Georgia Department of Natural Resources

Re: Corps ACF Operations Under the IOP

To: Carol Couch
From: Wei Zeng
Date: April 5, 2007
Re: IOP Concept 5 operation for the rest of year 2007

Fig. 9 Comparison of projected and observed (in 2000 through 2001) Lanier elevations

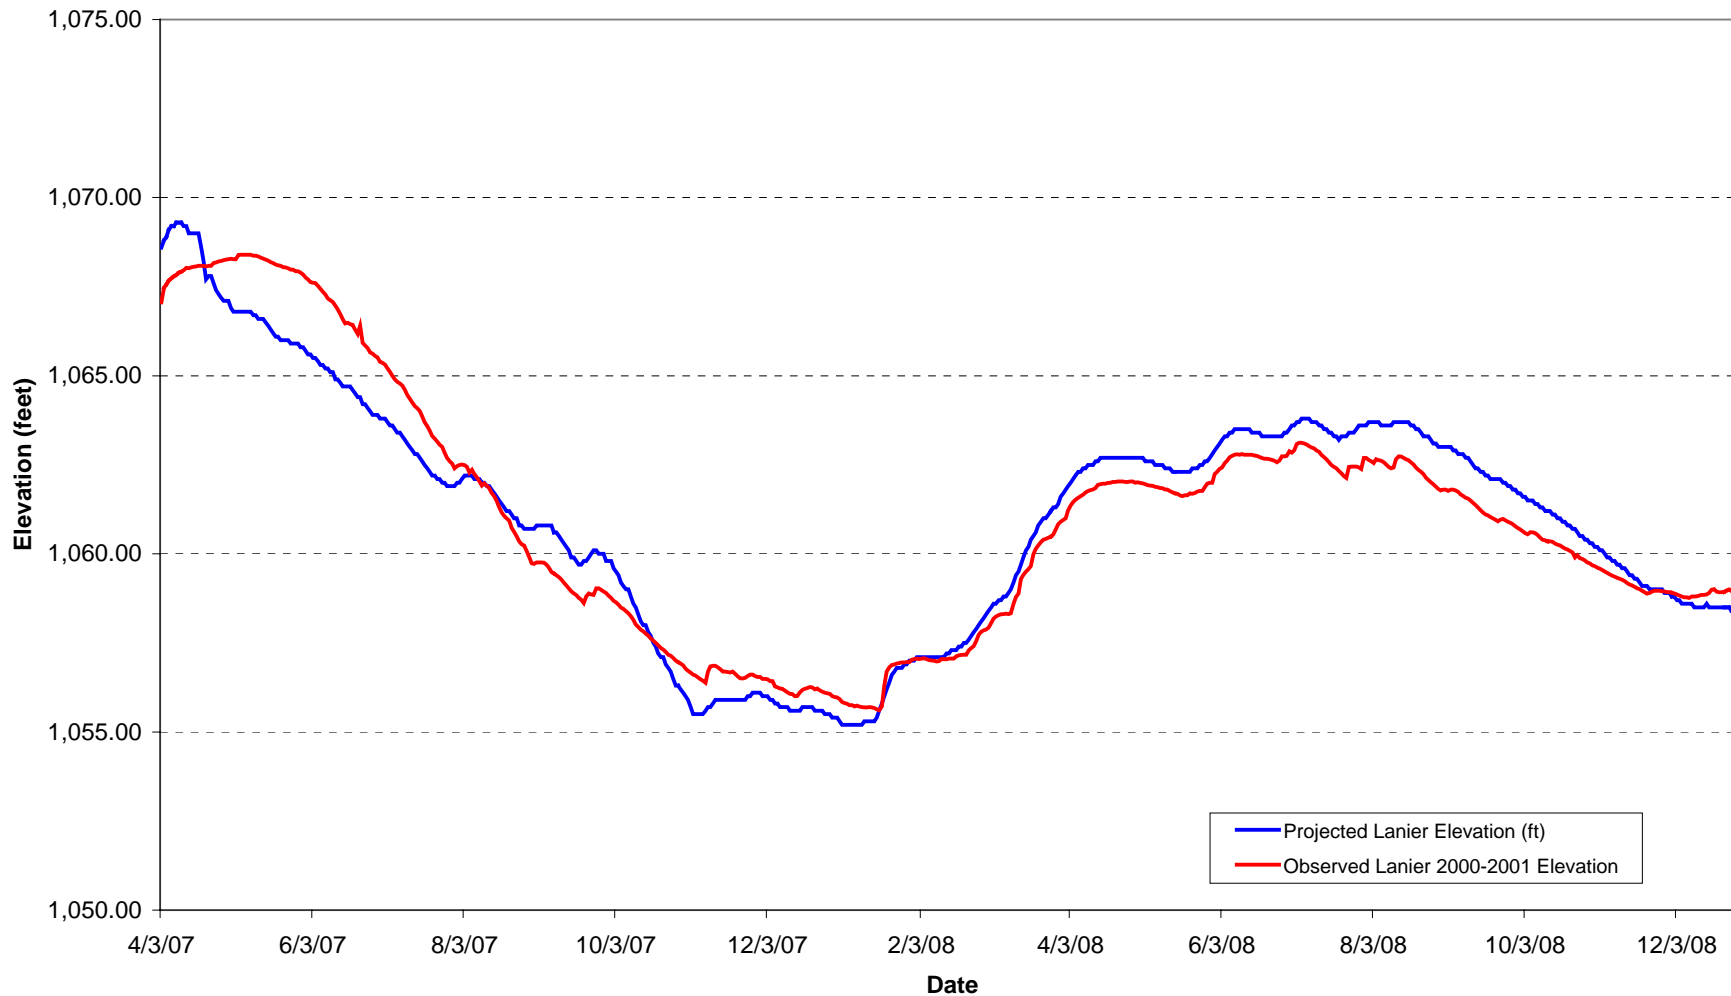
Fig. 9 depicts Lanier elevation dropping precipitously throughout much of the year until it reaches a level (just above 1055 feet) lower than seen in the year 2000. It then stays around 1055 feet for almost four months before starting to recover. Note that the observed 2000 low elevation was the result of a much-criticized navigation release in that year. What the model is telling us is that even if the Corps accurately executes the operations prescribed by IOP Concept 5, the impact of the IOP Concept 5 on Lanier would be worse than the 2000 navigation release. The Corps has stated in both its Biological Assessment and the Environmental Assessment that the flow requirements prescribed by the IOP Concept 5 are minimums, instead of targets. This means the simulation results, as bad as they are, still underestimate the risks.

Fig. 10 Observed 2006-2007 Lanier elevation and projected Lanier elevation for the rest of 2007 and 2008

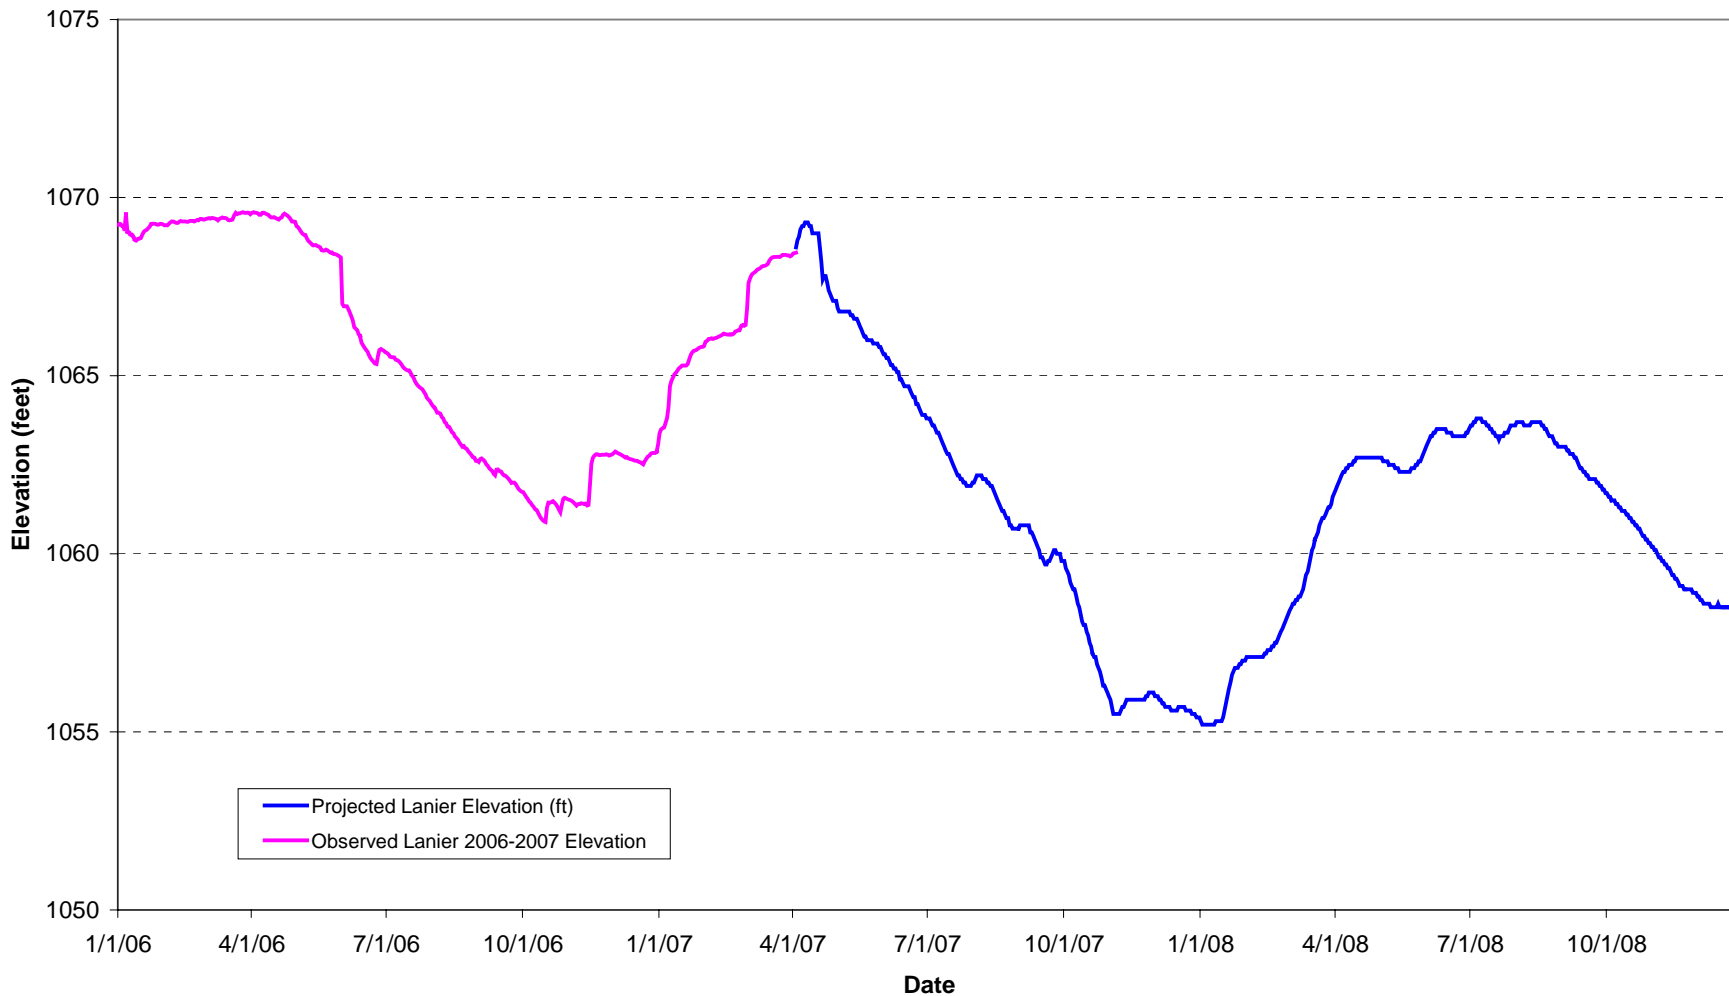
Presenting the same simulated scenario from a different perspective, Fig. 10 shows observed Lanier elevation in 2006 and early 2007 (in magenta) followed by simulated elevation for the rest of 2007 and 2008 (in blue). The IOP was first implemented in 2006, and its impact to the ACF system was apparent. In the past year, we have seen a historical loss of storage in a matter of a few months. The system storage recovered only because of near normal precipitation in the later part of 2006. What this analysis is telling us is that if the hydrological conditions of 2000-2001 take place in the ACF Basin for the rest of 2007 and 2008, we can expect Lanier low elevation to be more than 5 feet lower than in 2006, as a result of operations under the IOP Concept 5.

Fig. 11 Comparison of projected and observed (in 2000 through 2001) West Point elevations

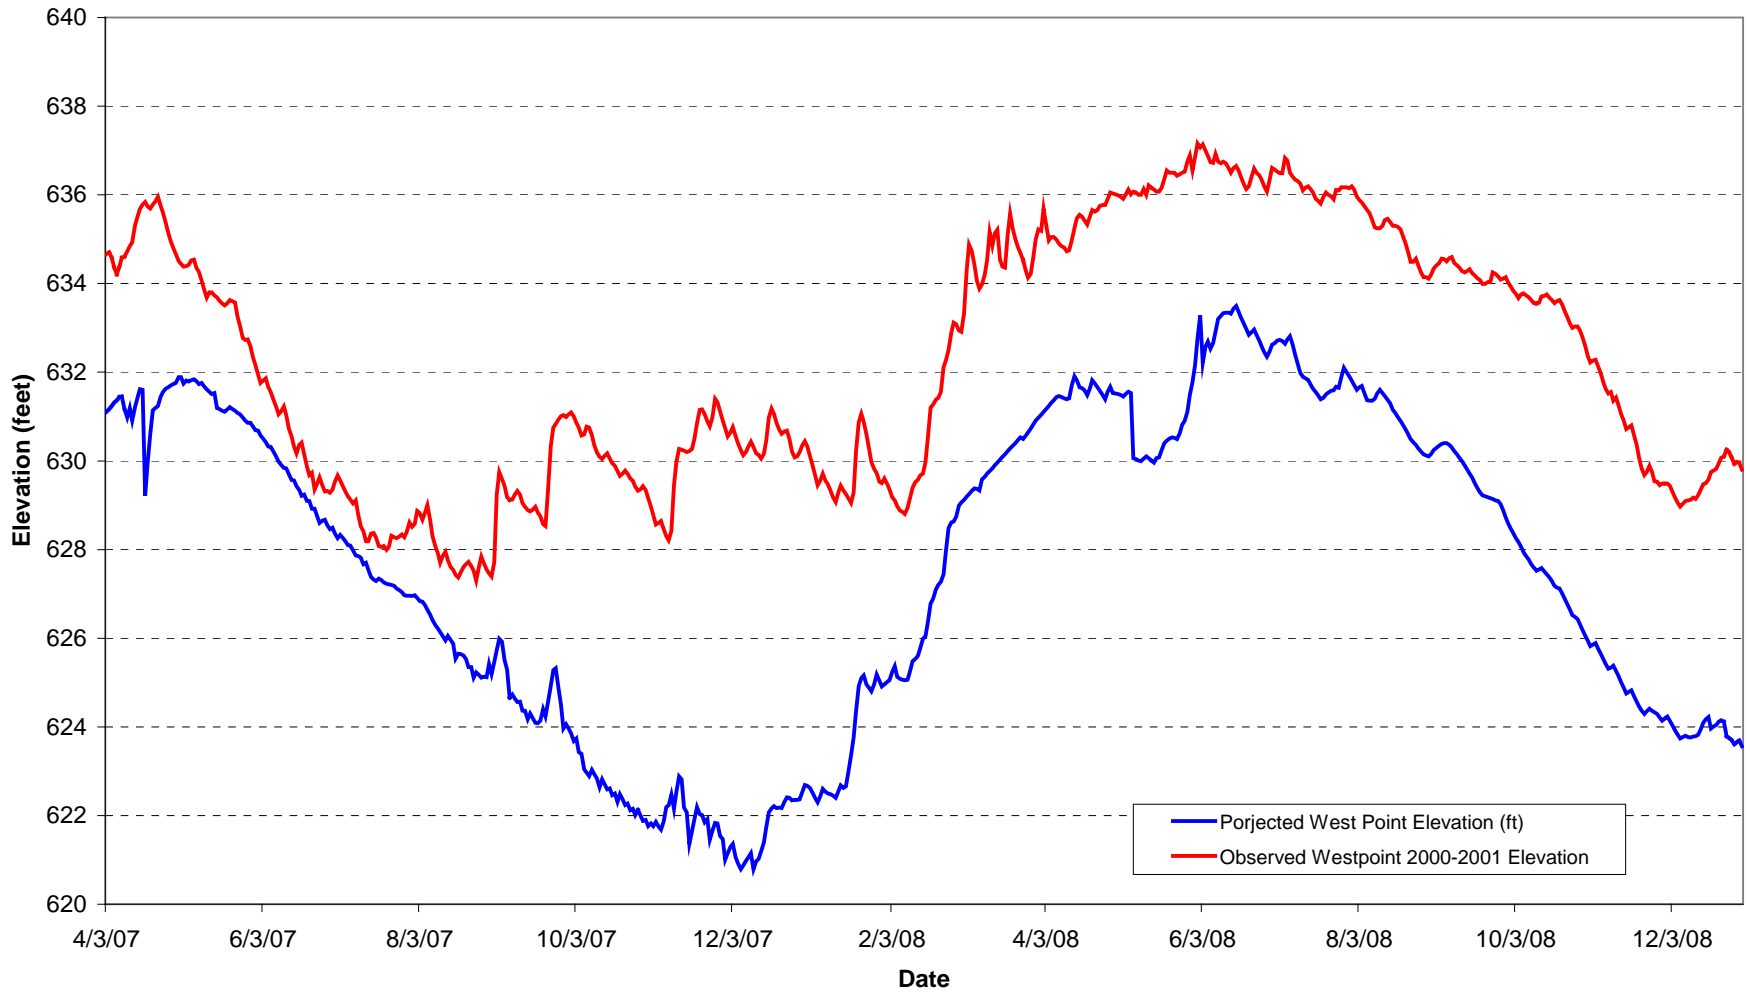
Fig. 11 shows West Point elevation being much lower compared to observations made in 2000 and 2001. West Point elevation would drop throughout most of the year and reach

the lowest point (621 feet) around early December 2007. At this point, West Point would be only one foot away from the bottom of its conservation pool. The average West Point elevation for the period of simulation (the rest of 2007 and 2008) would be 4.7 feet lower than that of the observation in 2000 and 2001.

Fig. 12 Observed 2006-2007 West Point elevation and projected West Point elevation for the rest of 2007 and 2008

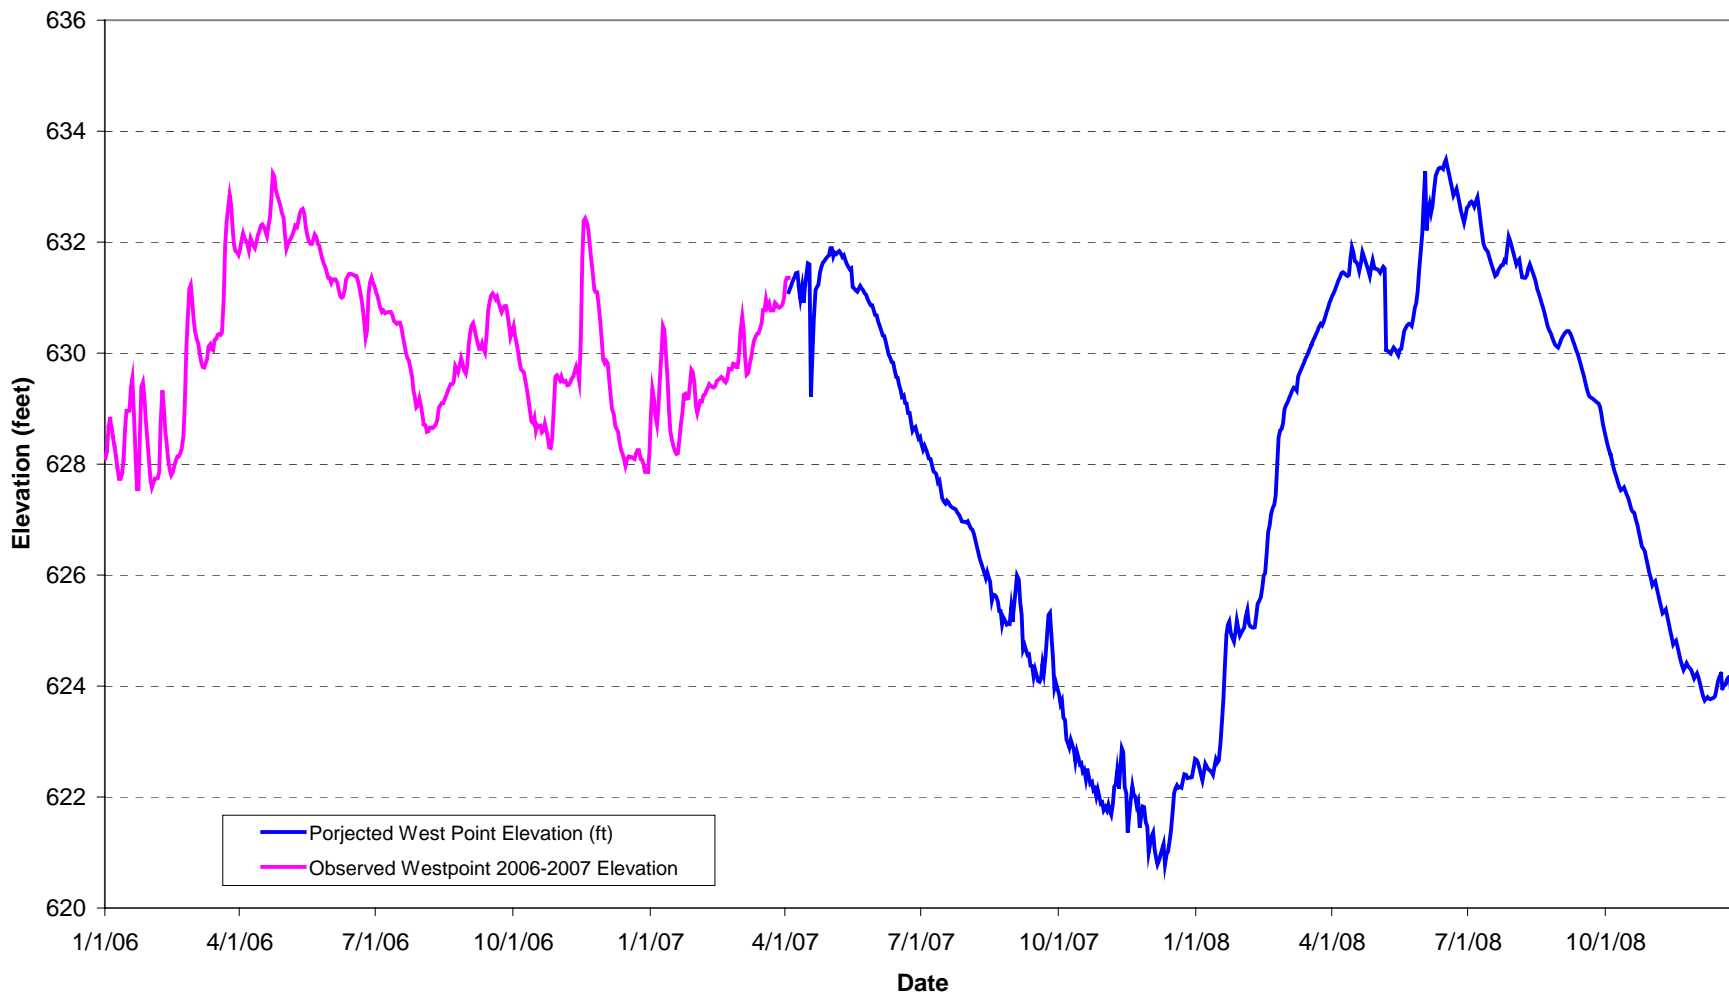
Fig. 12 depicts observed West Point elevation in 2006 to early 2007 followed by simulated elevation in the rest of 2007 and 2008. West Point was able to escape devastating low elevations because of near normal precipitations in the later part of 2006. However, if the 2000 hydrology is to repeat itself in the rest of 2007, and if the Corps implements the IOP Concept 5, we can expect to see a low West Point elevation of 621 feet, almost seven feet lower than in 2006.

Fig. 13 Comparison of projected and observed (in 2000 through 2001) Walter F. George elevations

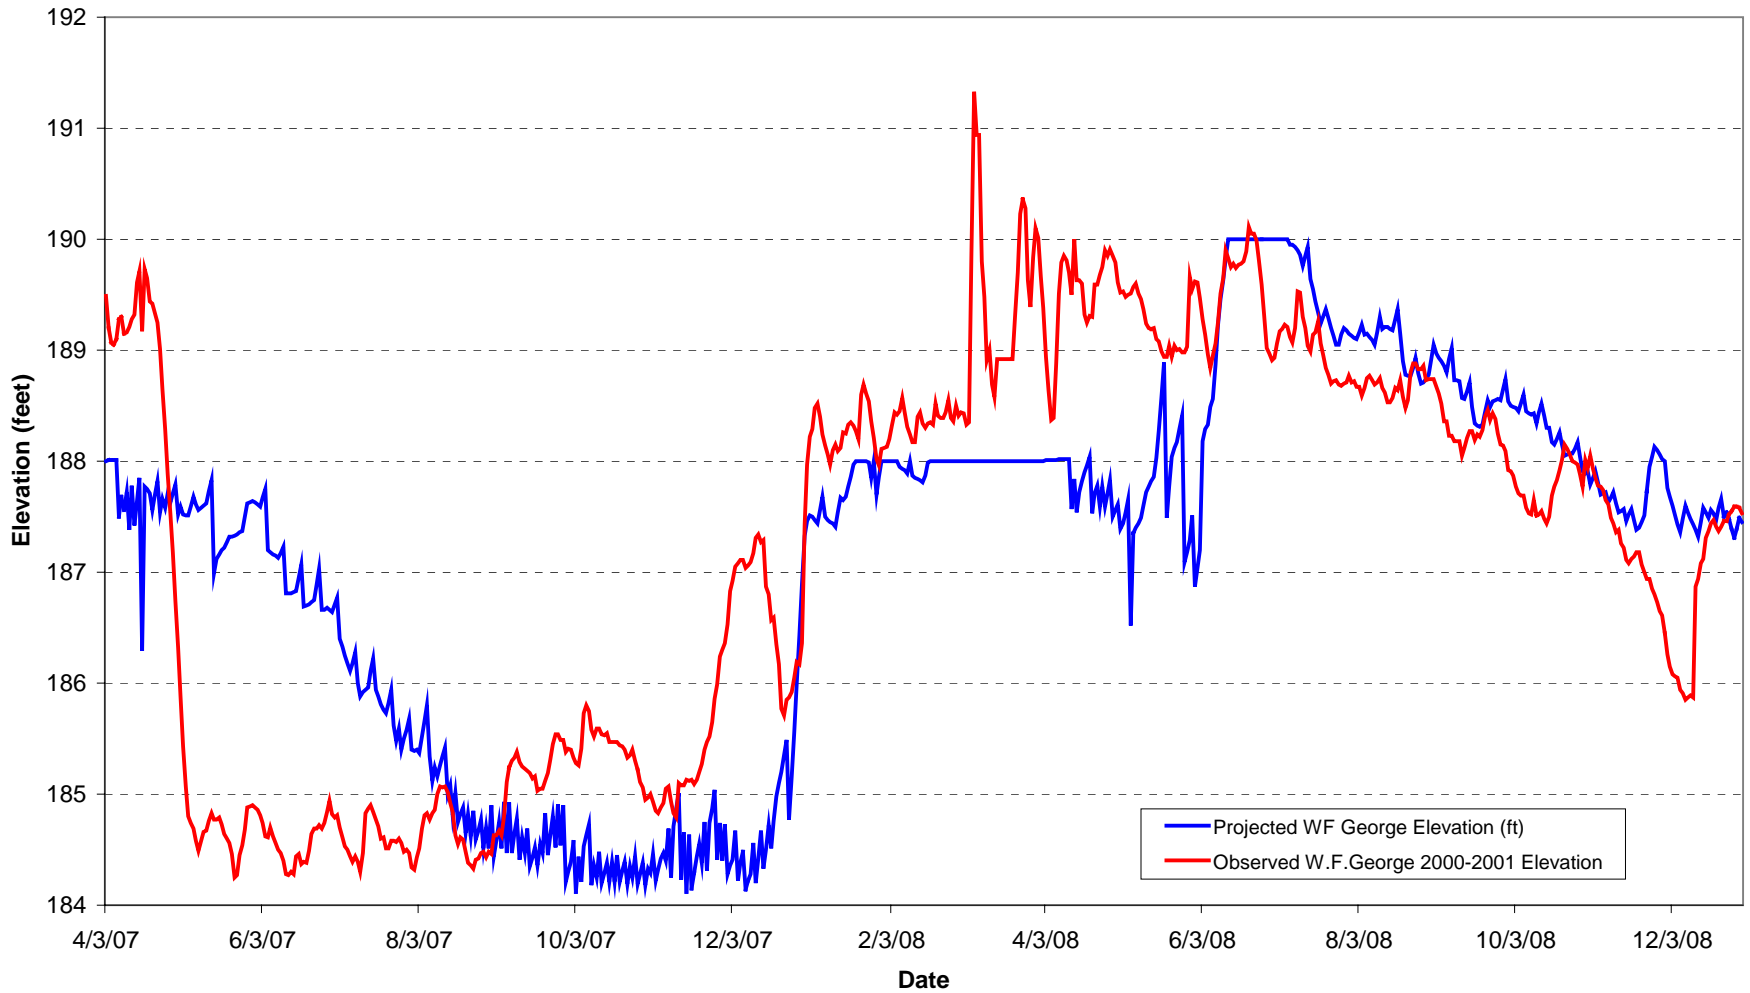
As a result of operations under IOP Concept 5, Walter F. George elevation would decline precipitously and reach 185 feet (only one foot away from empty) by early August. It would stay below 185 feet for about four months, in which it would be only inches away from the bottom of the conservation pool for numerous times (Fig. 13).

Fig. 14 Observed 2006-2007 Walter F. George elevation and projected Walter F. George elevation for the rest of 2007 and 2008

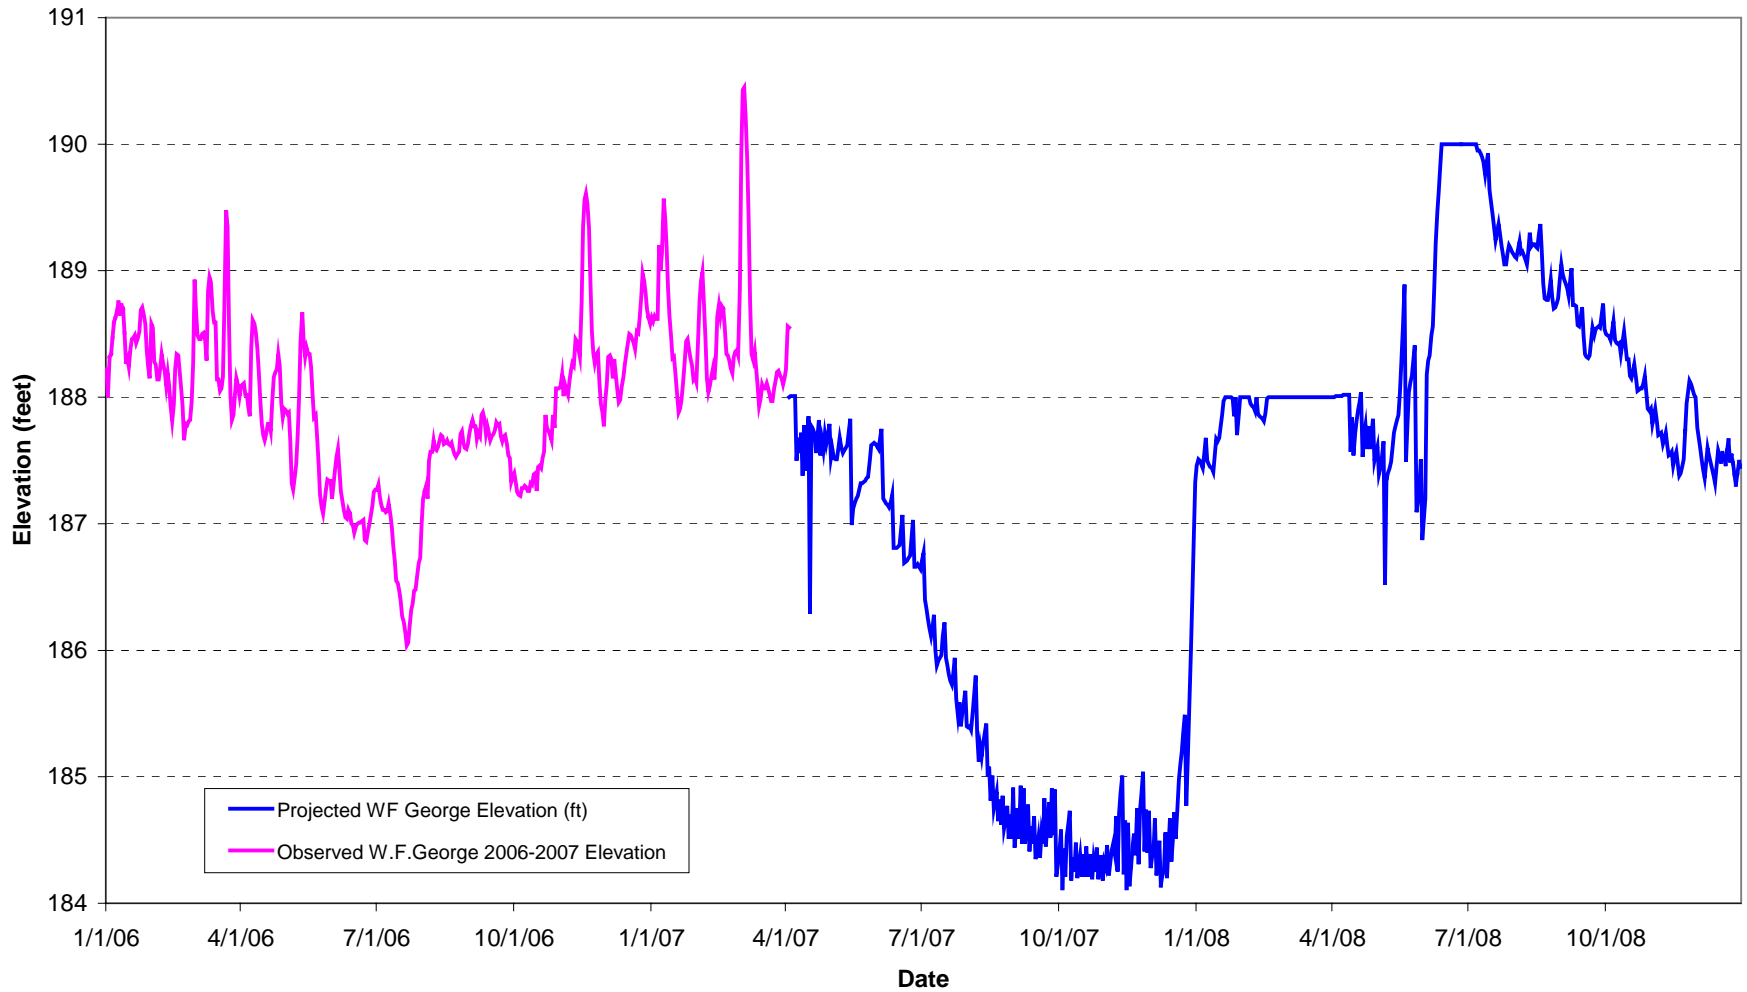
Fig. 14 shows observed Walter F. George elevation in 2006 to early 2007 followed by simulated elevation in the rest of 2007 and 2008. The low elevation of Walter F. George reached 186 in 2006. The lake recovered only because of near normal precipitations in the later part of 2006. With the assumption that the rest of 2007 will be like the drought year of 2000, the operations prescribed by the IOP Concept 5 will cause Walter F. George to be in a much worse shape (only inches away from its bottom of conservation pool) than in 2006 (Fig. 14).
